# Product Change Notification

## 108807 - 01

**Change Notification #:** 108807 - 01  
**Change Title:** Intel® WiFi Link 5000 Series Skus:  
512AN\_HMWG, HMWG2, MMWG,  
MMWG2, MMWW, MMWW2;  
533AN\_HMWG, HMWG2, MMWG,  
MMWG2, MMWW, MMWW2;  
512AG\_HMWG, 512AG.HMWG2,  
512AG\_MMWG, 512AG.MMWG2,  
PCN 108807-01, Label, Add Peru regulatory  
marking and DSPR statement, OUI Updates,  
**Reason for Revision: Correction to label  
examples**  
**Date of Publication:** September 22, 2008

Example Labels for addition of Peru Regulatory and Japan “Indoor Use” verbiage

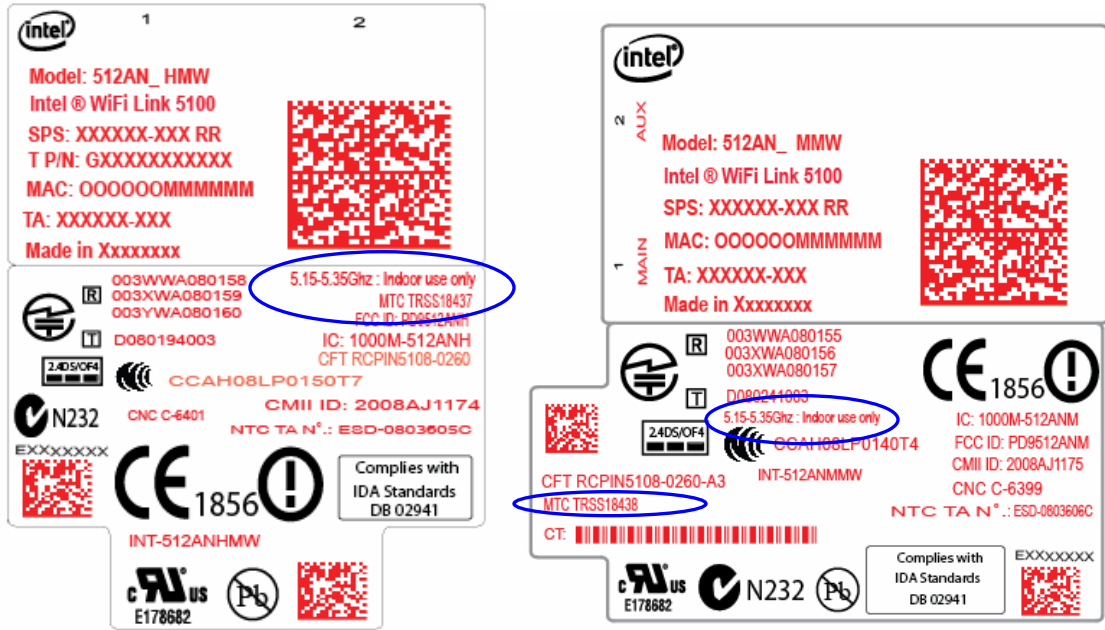
1. Addition of Peru Regulatory approval numbers as follows:

**512AN\_HMW: MTC TRSS18437**  
**533AN\_HMW: MTC TRSS18435**  
**512AN\_MMW: MTC TRSS18438**  
**533AN\_MMW: MTC TRSS18436**

2. Add “INDOOR USE” verbiage to label as per Japan DSPR requirement on all 512AN and 533AN SKUs as follows :

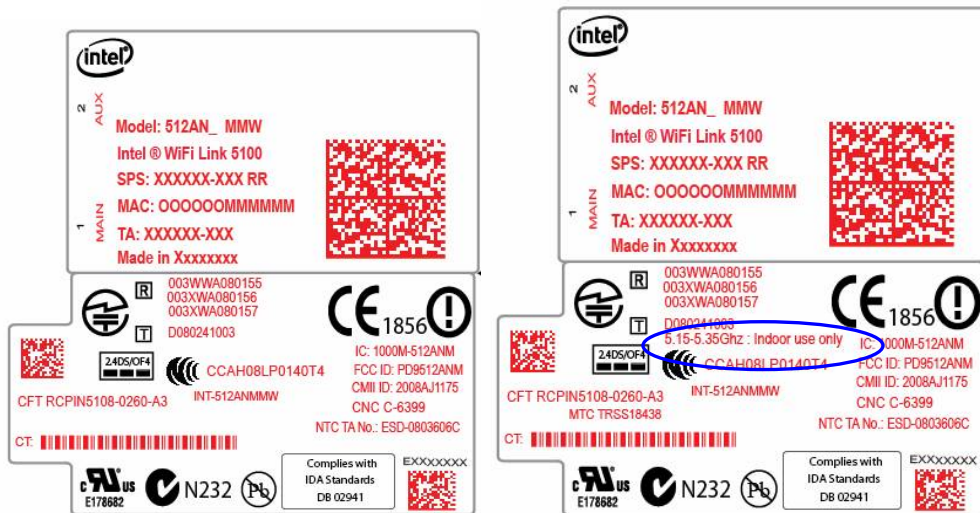
1. Addition of Peru Regulatory approval numbers as follows:

512AN\_HMW: MTC TRSS18437  
533AN\_HMW: MTC TRSS18435  
512AN\_MMW: MTC TRSS18438  
533AN\_MMW: MTC TRSS18436

2. Add “INDOOR USE” verbiage to label as per Japan DSPR requirement on all 512AN and 533AN SKUs as follows :
